UTILITY SERIAL NUMBER	PATENT DATE JAN 27 1998	PATENT NUMBER
SERIAL NUMBER 08/433,623	FILING DATE 05/03/95	CLASS 156
	SUBCLASS 643,1	GROUP ART UNIT
		EXAMINER A. HIGGINS

APPLICANTS DANIEL L. FLAMM, WALNUT CREEK, CA; JOHN P. VERBONCOEUR, HAYWARD, CA.

TITLE PROCESS OPTIMIZATION IN GAS PHASE DRY ETCHING

FIG. 7

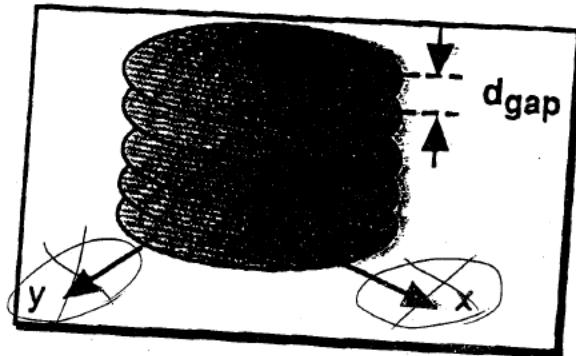
In Fig. 7, the two Cartesian axes at the bottom of the informal drawing are deleted.

With respect to Fig. 7, the two Cartesian axes at the bottom of the informal drawing are deleted because they are not referenced or used in the radial coordinate system of this figure.

FIG. 1

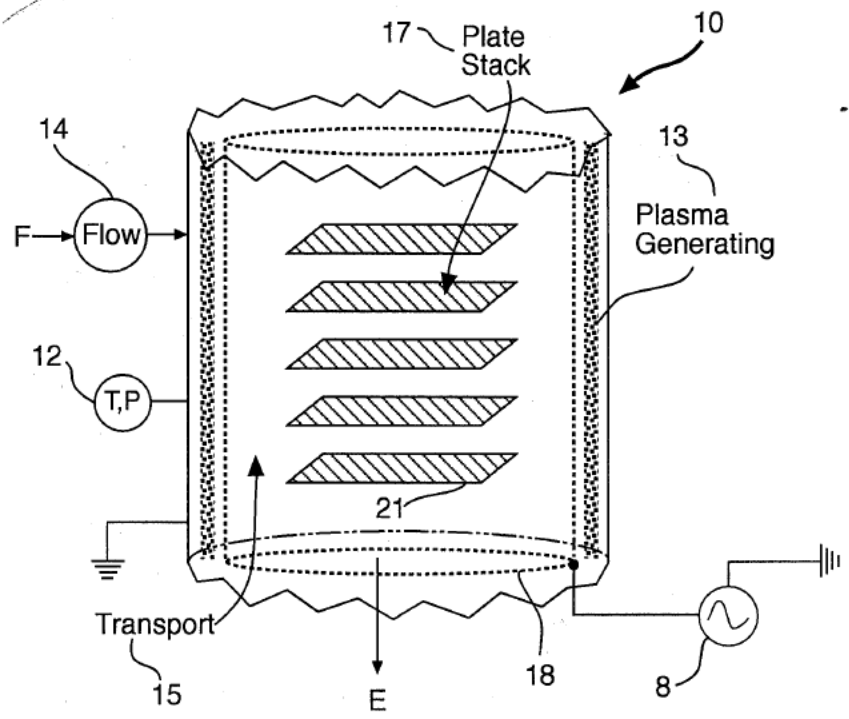
In Fig. 1, chemical flow source 14 was detached from the chemical feed F . In the new formal drawings chemical feed F is shown passing through the chemical flow source 14. Also, the ground connections have been amended to more clearly show the complete circuit for the rf discharge 8. Furthermore, the arrow indicating the exhaust E is moved to the chamber bottom.

With respect to Fig. 1, in the new formal drawings, chemical feed F is correctly shown passing through the chemical flow source 14. See, e.g., Specification, page 4, lines 15-22. Also, the ground connections now more clearly show the complete circuit for the rf discharge 8. Furthermore, the arrow indicating the exhaust E is moved to the chamber bottom for clarity because no opening is shown on the chamber side.

FIG. 3

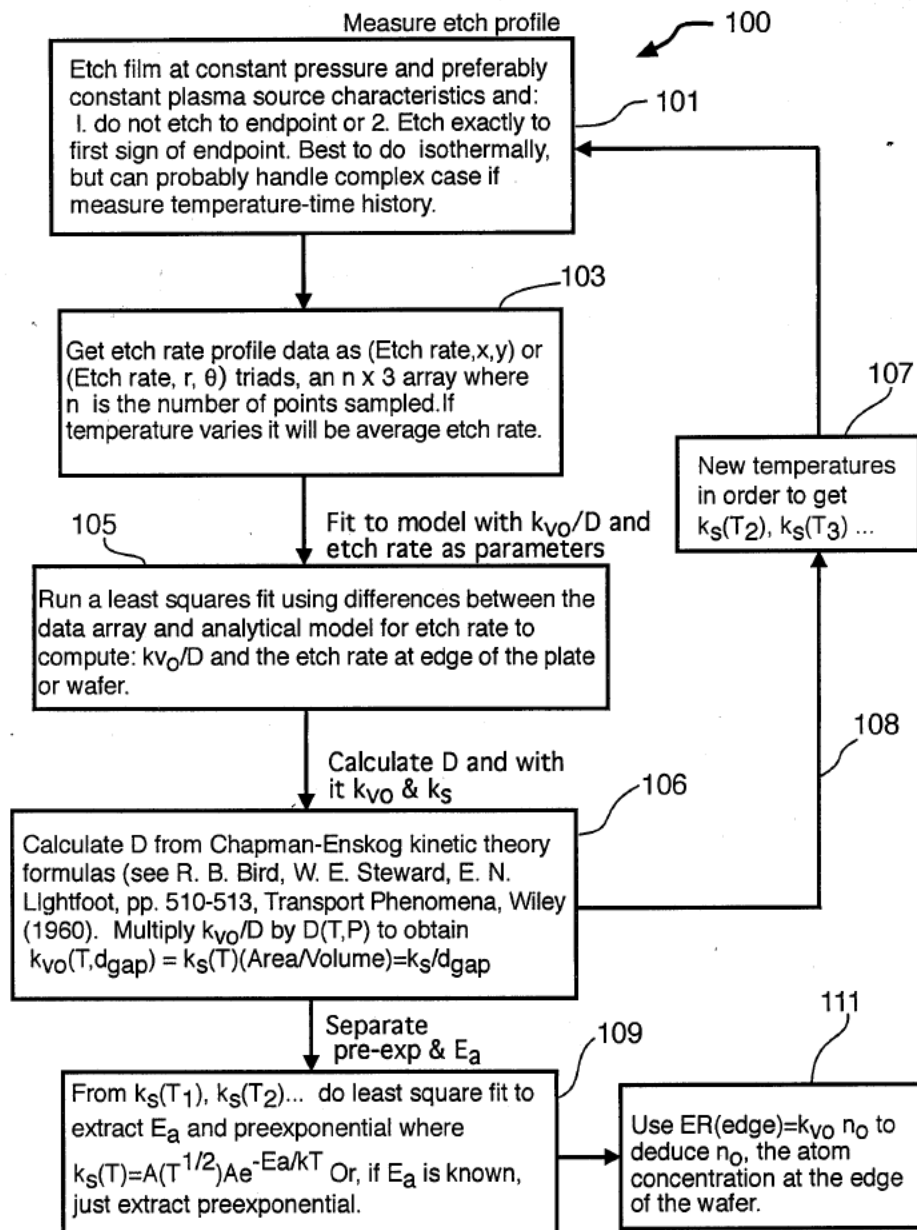
In Fig. 3, as highlighted in red ink, some editorial changes are made in boxes 105, 106, 107, and 109. For example, in box 109 $k_i(T)$ has been replaced with $k_s(T)$. In box 106, "z" has been replaced with " d_{gap} ". Similarly in box 107, "k" has been replaced with " k_s ". In box 109, k_i has been replaced with k_s and "preexponential" has been added at the end.

With respect to Fig. 3, some editorial changes are made in boxes 105, 106, 107, and 109 for consistency with the Specification or to correct some typographical errors. For example, in box 109 $k_f(T)$ is replaced with $k_s(T)$ to maintain consistency with the text. See, e.g., Specification, page 11, the equation after line 15. In box 106, "z" is replaced with " d_{gap} " for consistency with the Specification, for example, at page 11, the equation after line 5. Similarly in box 107, "k" is replaced with " k_s " for consistency with the Specification.

FIG. 4

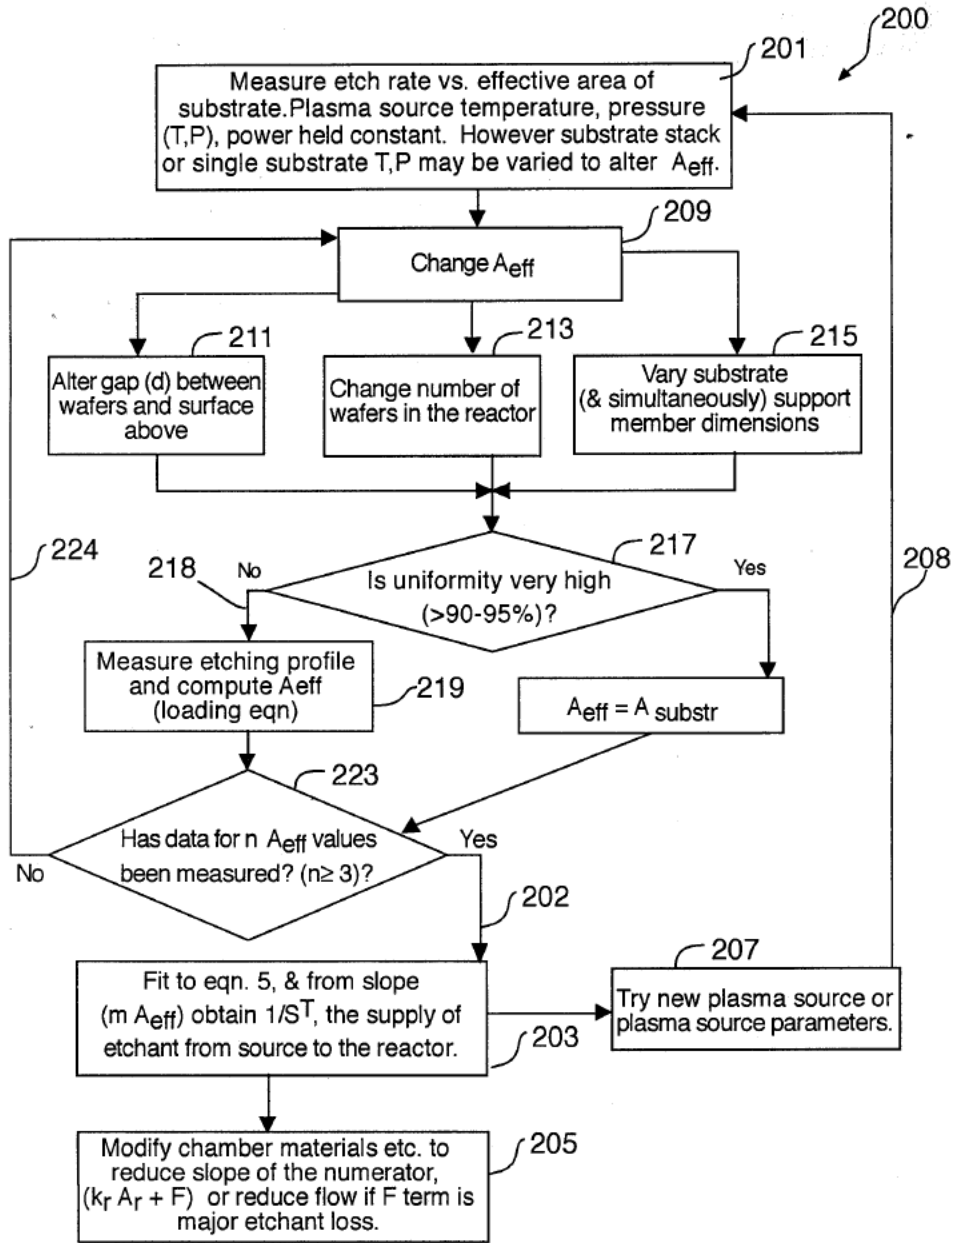
In Fig. 4, some editorial changes are made in boxes 203 and 205. In box 203, "St" is replaced by " S^m ". In box 205, "of" is added after slope.

FIG. 12

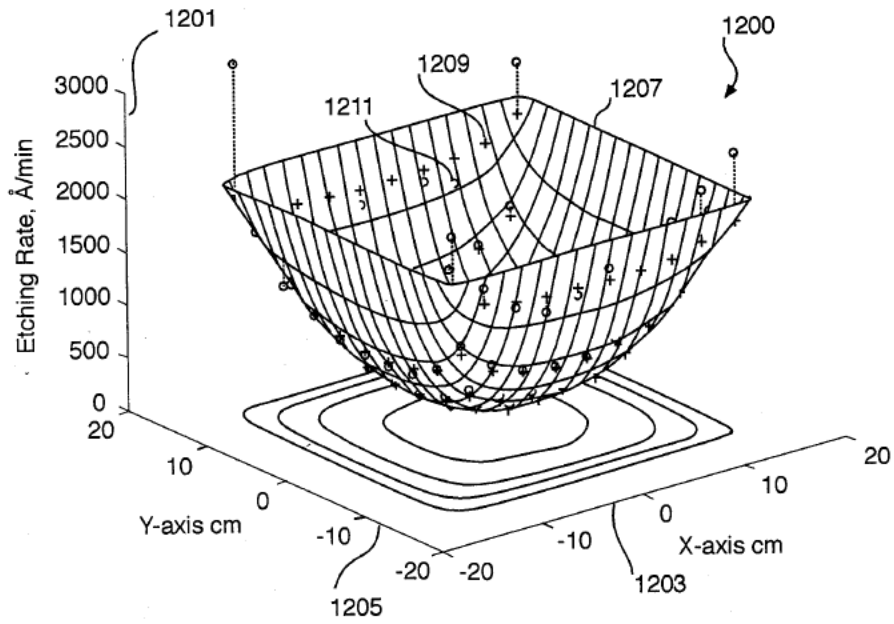
In Fig. 12, the units on the y-axis are changed. Also, the downward spikes at the four corners of the informal drawing are deleted.

In Fig. 12, the units shown on the y -axis of the newly submitted formal drawing are twice as great as the units shown in the original informal drawing. This amendment corrects a typographical error made when making the original drawing. While Applicant believes that those skilled in the art would understand the invention and the error in Fig. 12, this correction is made to avoid any possible confusion on the part of the reader. Also, the downward spikes at the four corners of the informal drawing are absent in the formal drawing. These spikes were the result of utilizing a limited number of mathematical terms to generate the plotted surface. The gridded pattern shown in the formal drawing has no spikes, for example, in accordance with the complete equation in the Specification at page 24, after line 10, and the text at page 26, lines 1-4.
